CALL NO. 102
CONTRACT ID NO. 121001
ADDENDUM # 2

Subject: Pike County, APD 0806 (040)
Letting January 27, 2012

- (1) Revised - Plan Sheets - T1, T56, T57, & T58
- (2) Revised - Bid Items - Pages 84-88 of 88

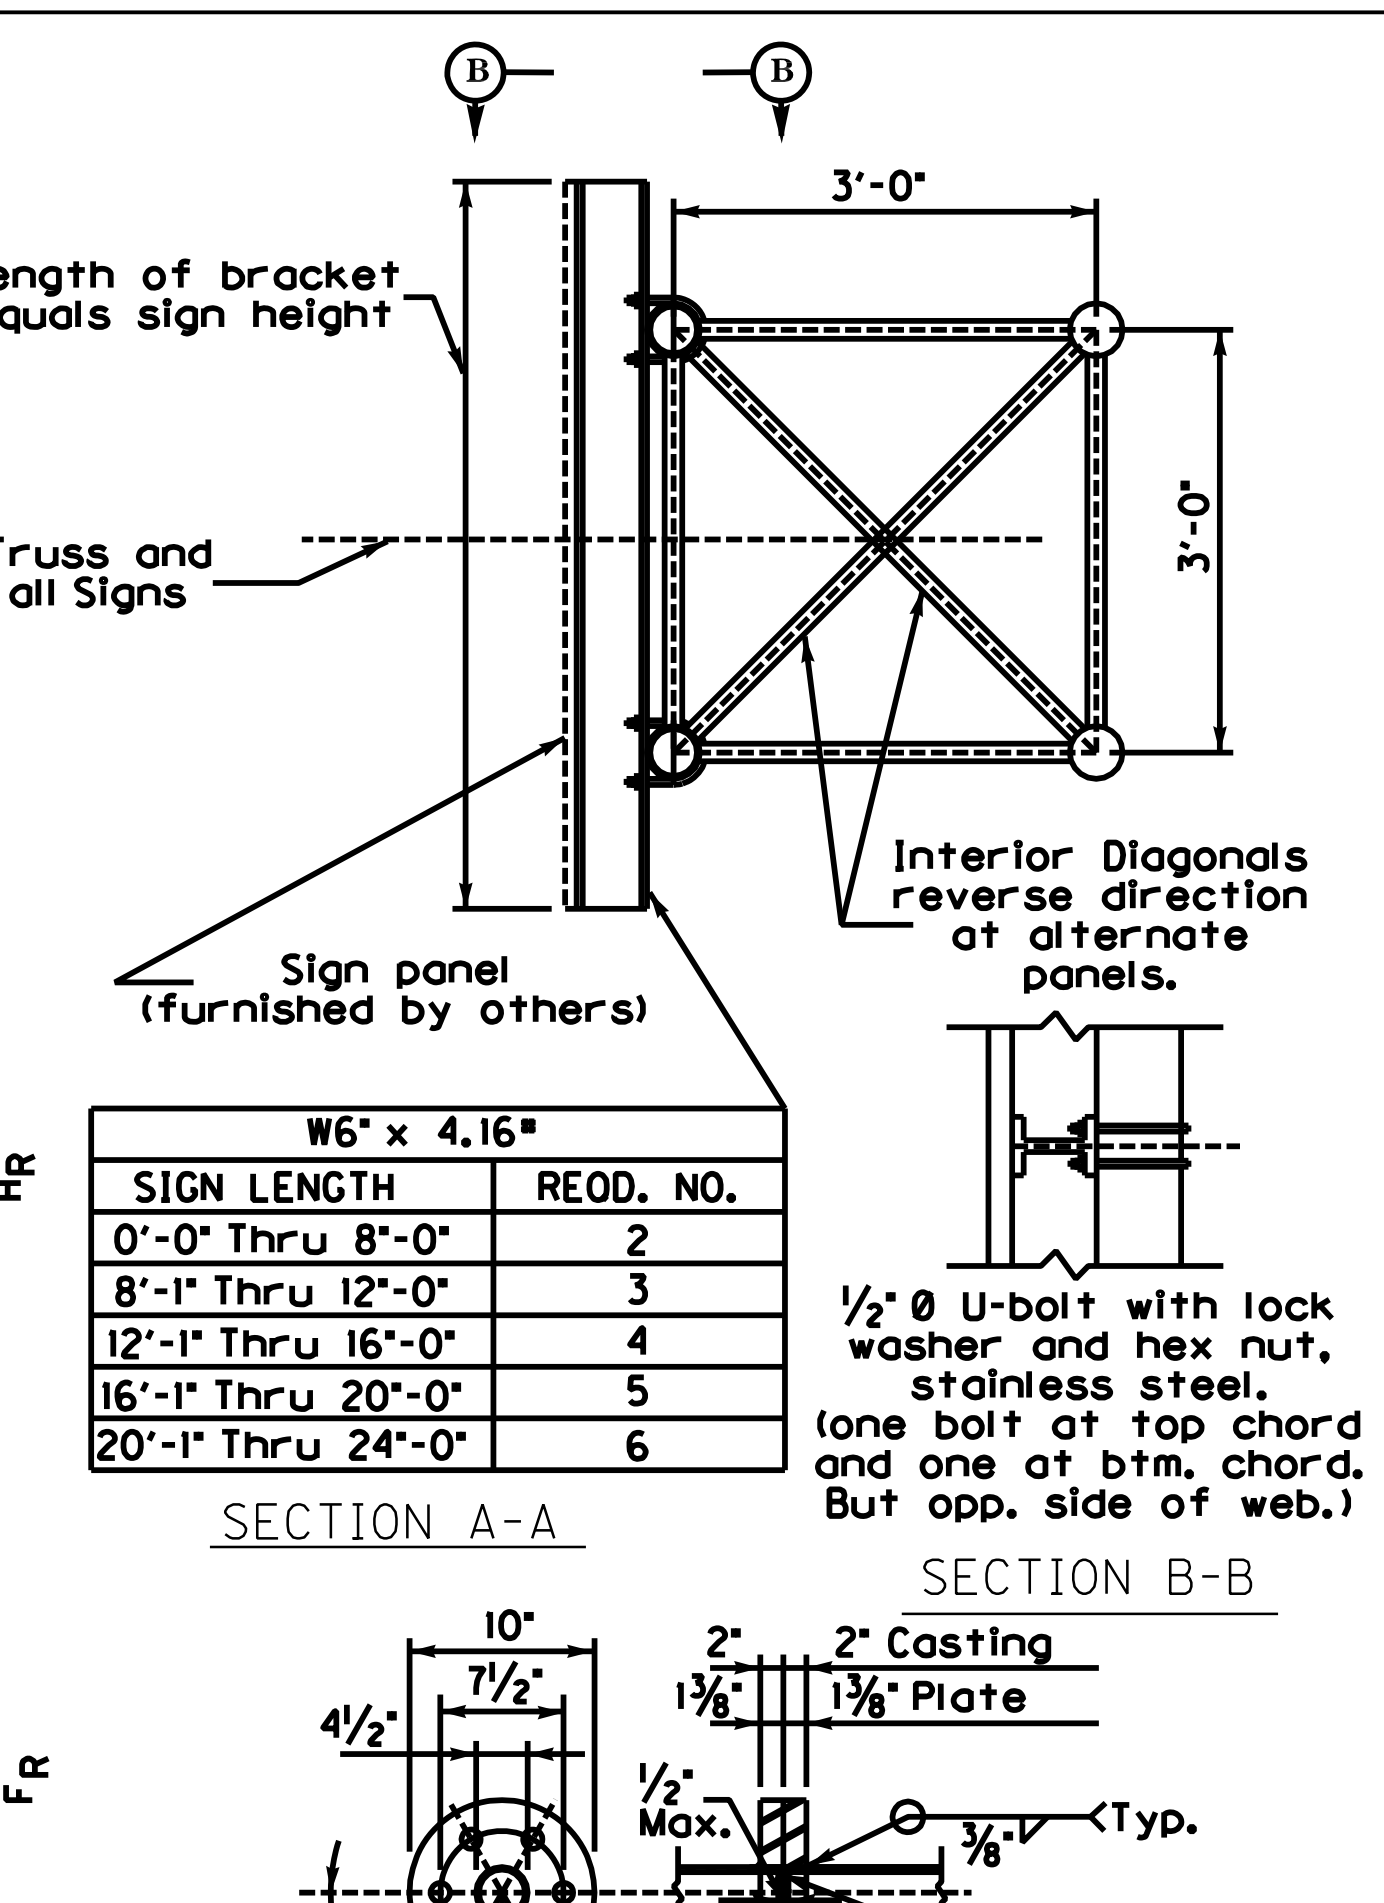
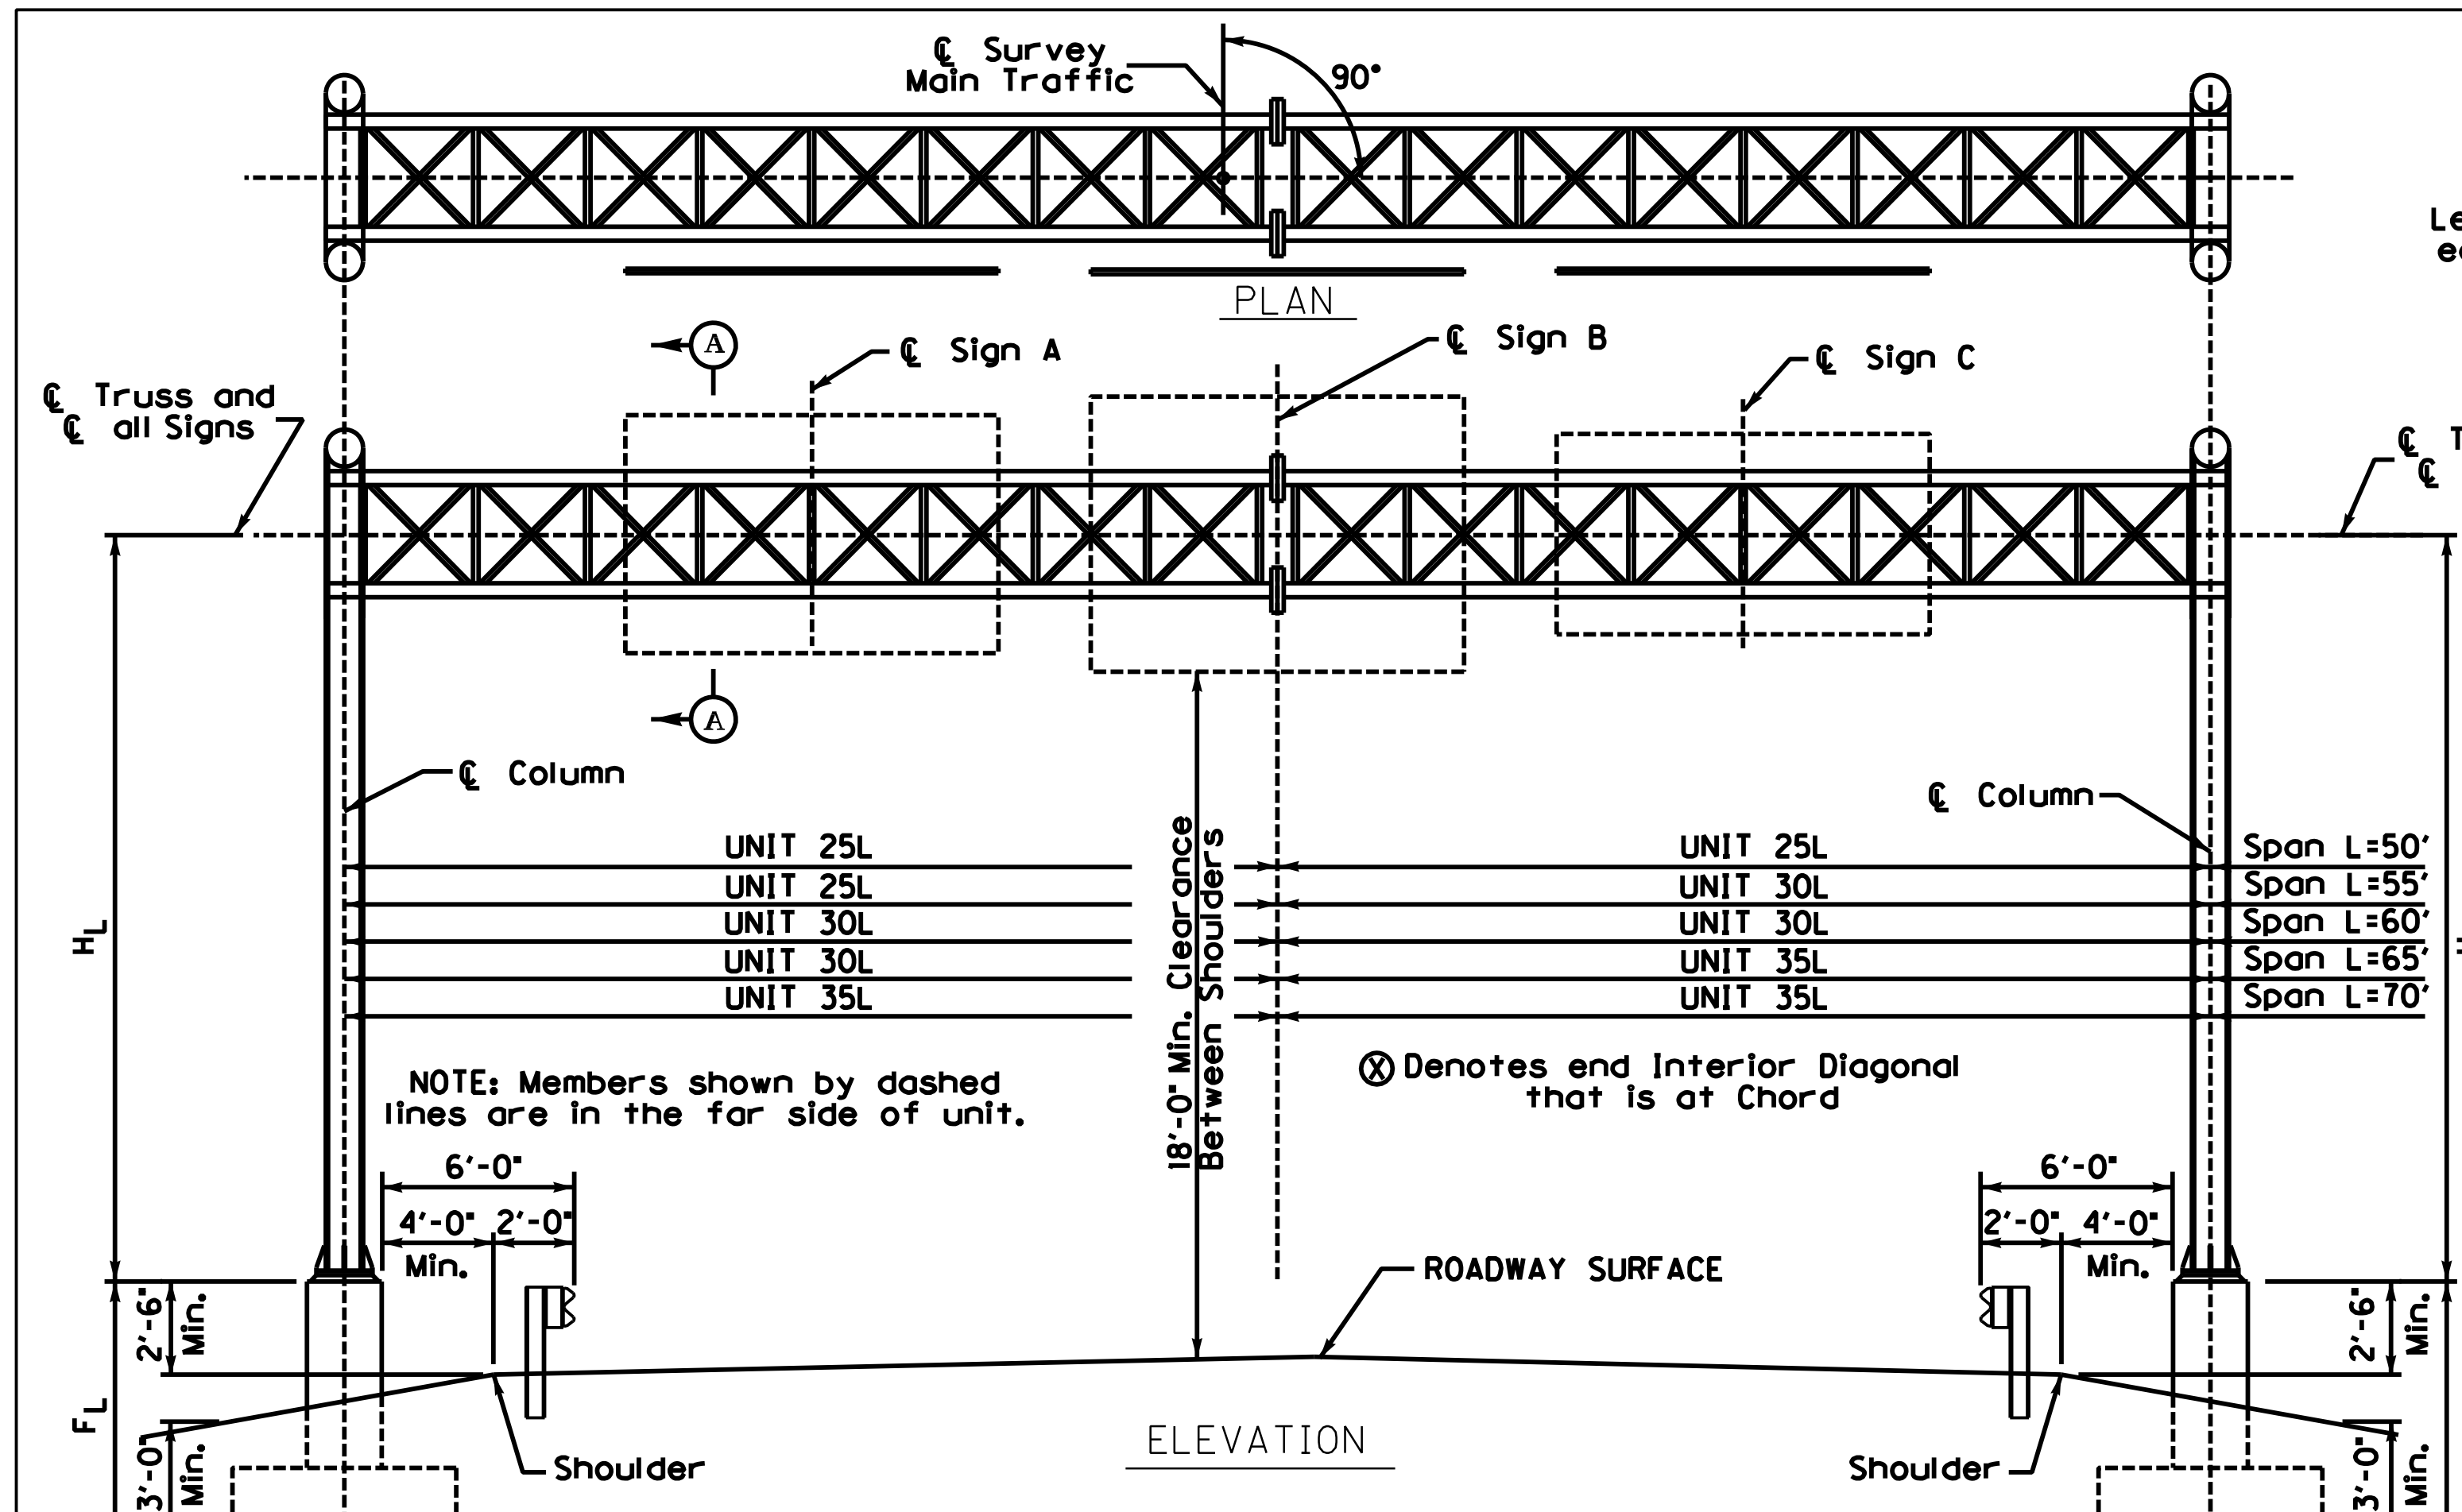
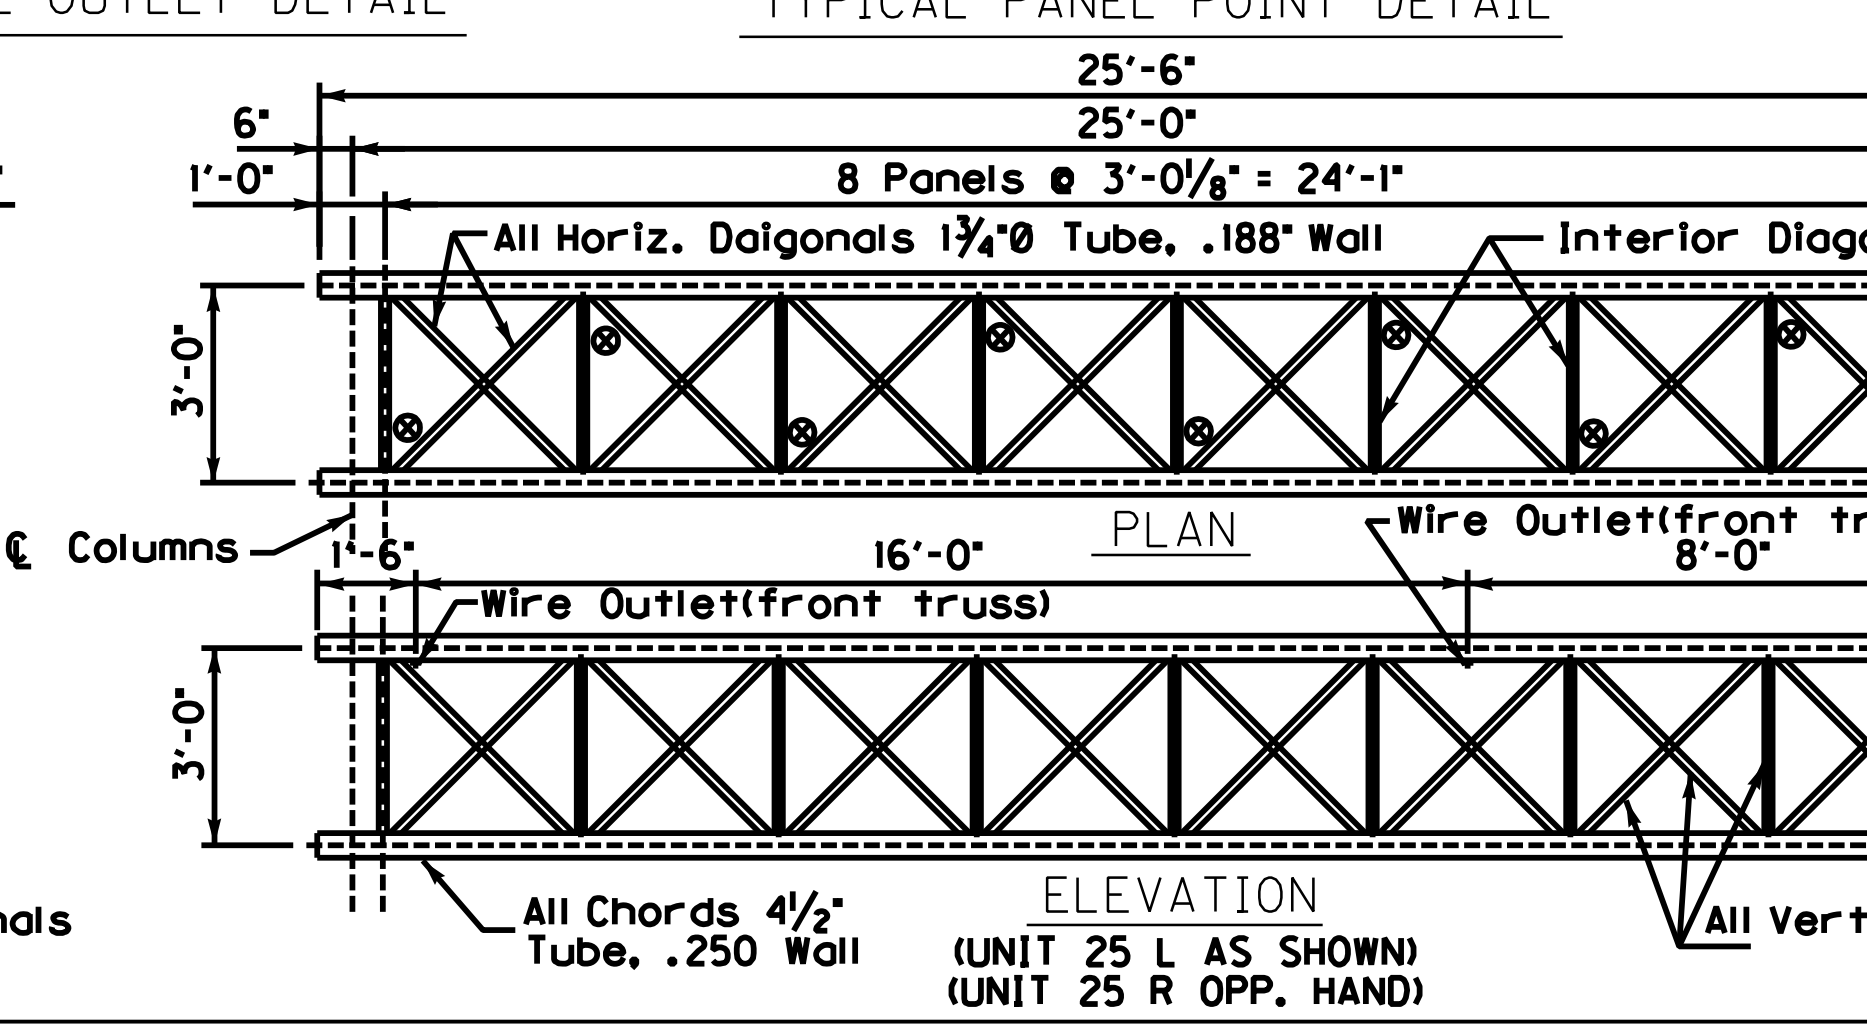
STA. 1+160
 NOTE: SIGN TRUSS FOUNDATION DATA (UP TO BASE PLATE) FOR INFORMATION ONLY. SUPERSTRUCTURE TO BE CONSTRUCTED UNDER THIS PROJECT.
